Re: Site address: 20 & 22 Forest Street , FOREST LODGE NSW 2037, 13 & 15 Ross Street , FOREST LODGE NSW 2037 Appeal to the Land & Environment Court: RE-NOTIFICATION (COURT APPEAL)

This submission focuses on the proposed change to the Forest Street elevation of the DA. In our view demolition of the houses at 20 and 22 Forest Street is not justified and the changes to the design of the Forest Street elevation do not alter this.

Figure 1 Numbers 20 and 22 along with 18 Forest Street comprise a group of three single storey early vernacular houses

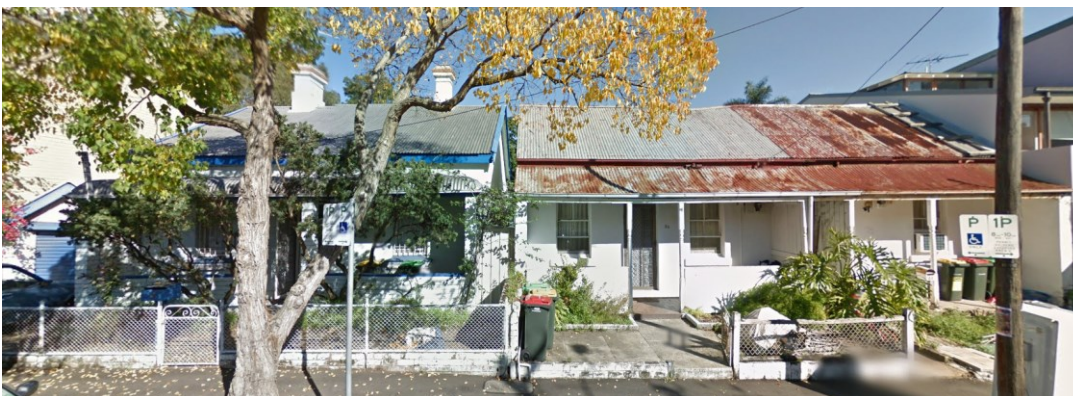
The fact that there are only a small number of these one storey mid-19th century workers cottages in the precinct; Lodge Street has two; Forest Street has three; St Johns Road two and that number 18, 20 and 22 Forest Street (the three Forest Street ones) are the only grouping of the typology, reinforces the importance of 20 and 22 Forest Street to the Heritage Conservation Area and the need to keep them.
